LEE'S SUMMIT HYUNDAI PREMIER AUTO OUTLET

PROJECT DESCRIPTION:
NEW HYUNDAI AUTOMOBILE DEALERSHIP WITH SHOWROOM AND VEHICLE SERVICE AREA.

Civil Addendum #1 Items:
1. Moved vehicle display pad and added curbs and added pavement connecting parking lot to pad.
2. Added crosswalk striping at main entrance.
3. Enlarged concrete pavement area in front of trash enclosure.
4. Added 5 bollards inside trash enclosure.
5. Changed sanitary sewer service from "PVC" to "SDR 26 PVC"
6. Moved two ADA stalls from SW corner of parking lot to east side of building.
7. Removed all parking blocks.
8. Added turn down sidewalk on east side of building near NE corner.

Civil Addendum #2 Items:
1. Added designations and dividing line between two major sections of site work: East Road and Main Site.
2. Reduced extent of Rock Blanket at 72" pipe end section.
3. Added Project Note stating that seeding is required.
4. Added electrical service conduits and pad mounted transformer location.
5. Added gas service line.
6. Added data/telecom conduits

WATER & FIRE LINE PLAN

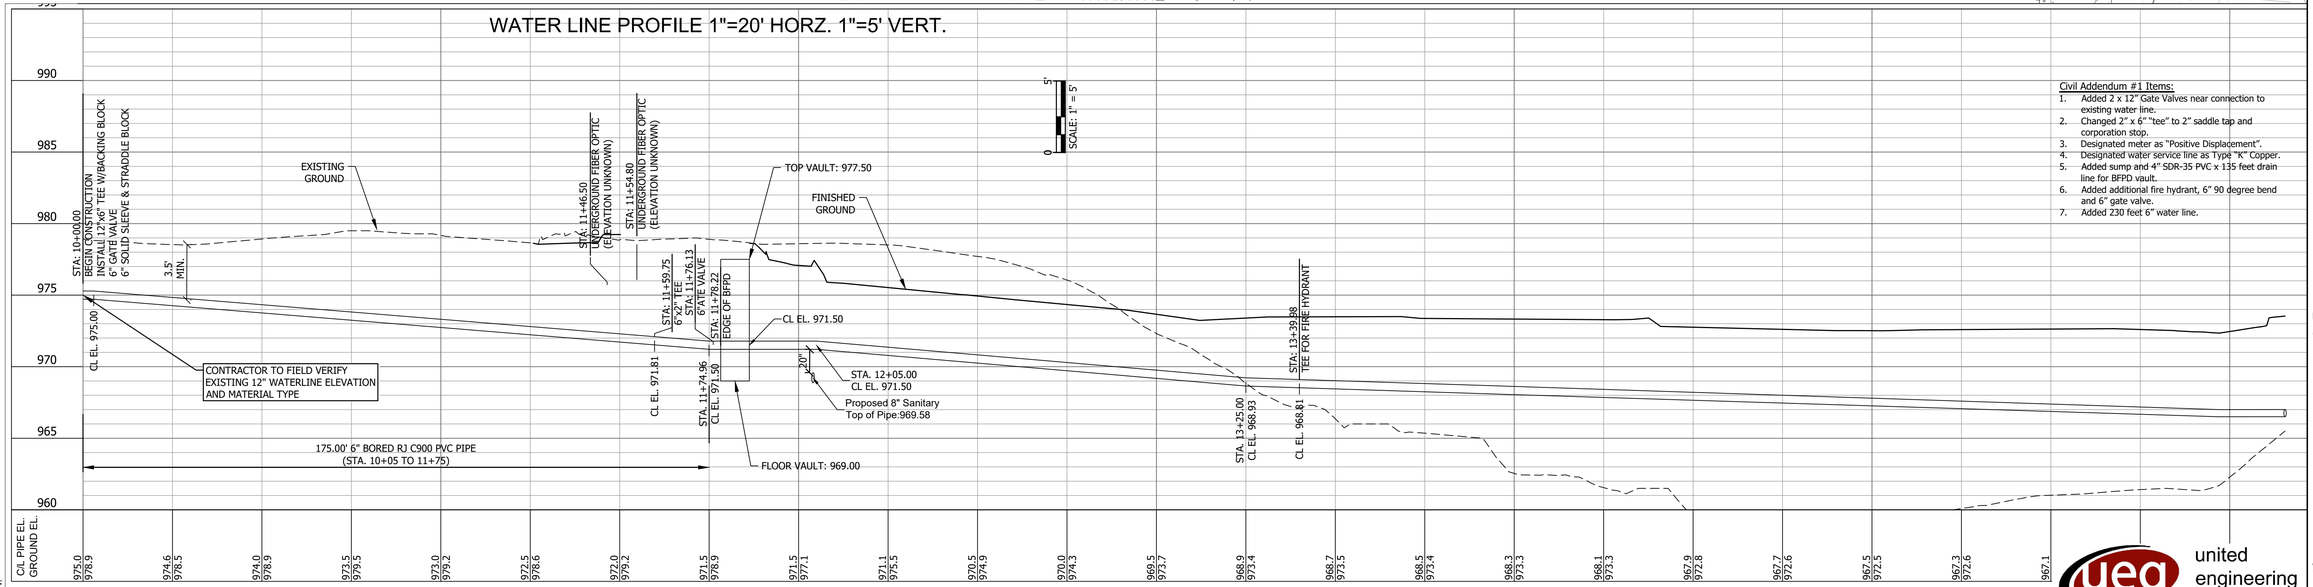
Civil Addendum #1 Items:
1. Added 2 x 12" Gate Valves near connection to existing water line.
2. Changed 2" x 6" "tee" to 2" saddle tap and corporation stop.
3. Designated meter as "Positive Displacement".
4. Designated water service line as Type "K" Copper.
5. Added sump and 4" SDR-35 PVC x 135 feet drain line for BFPD vault.
6. Added additional fire hydrant, 6" 90 degree bend and 6" gate valve.
7. Added 230 feet 6" water line.

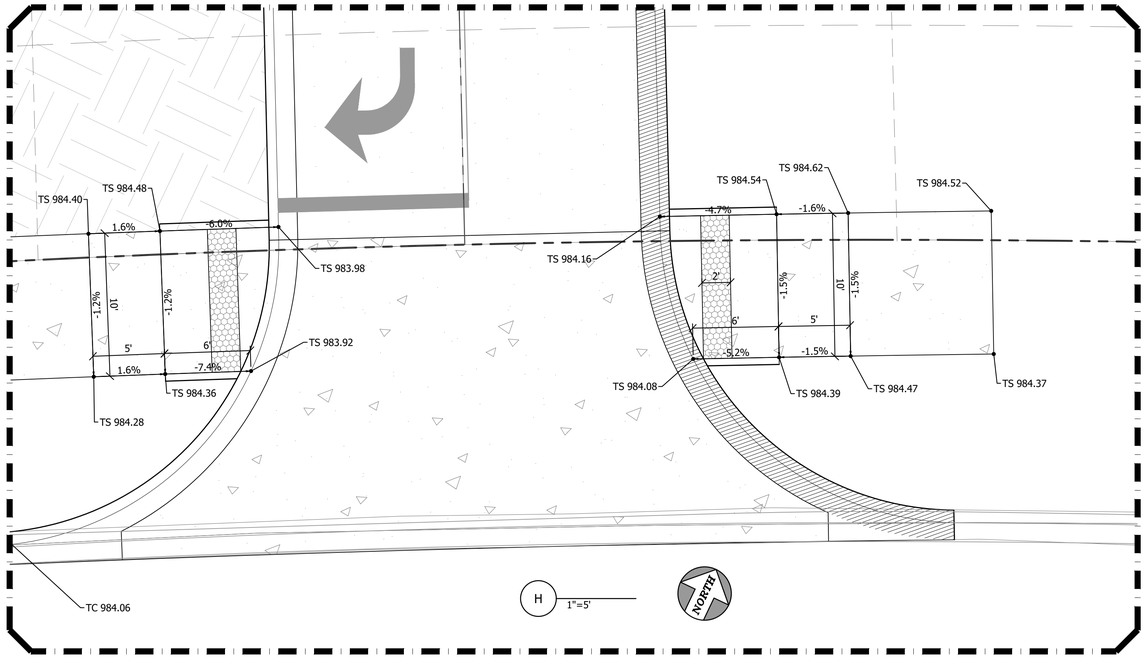
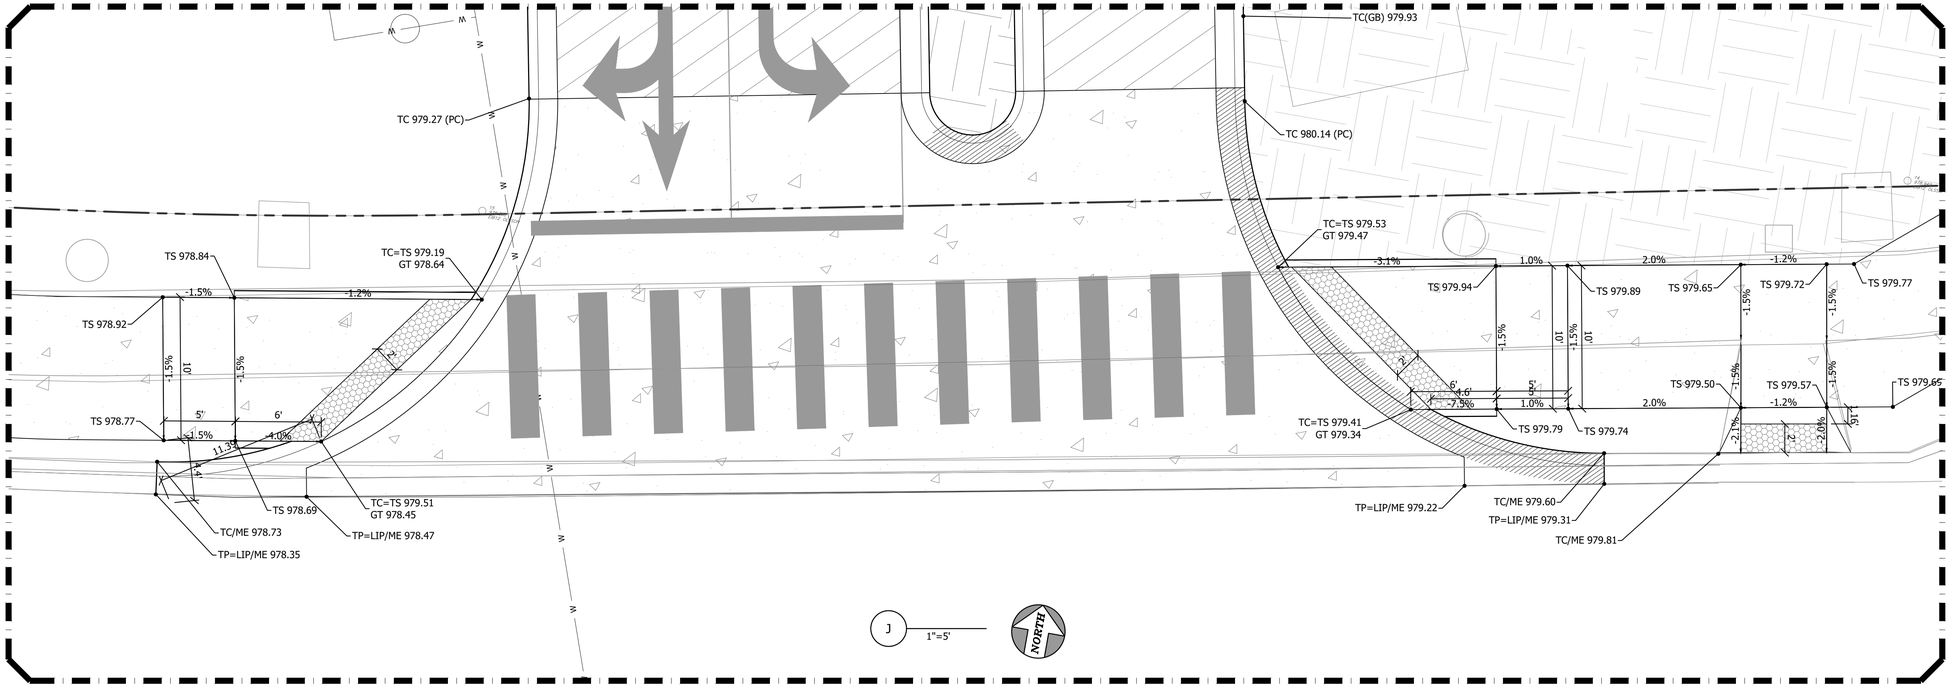
Civil Addendum #1 Items:
1. This sheet has been added to add clarity to ADA grading.
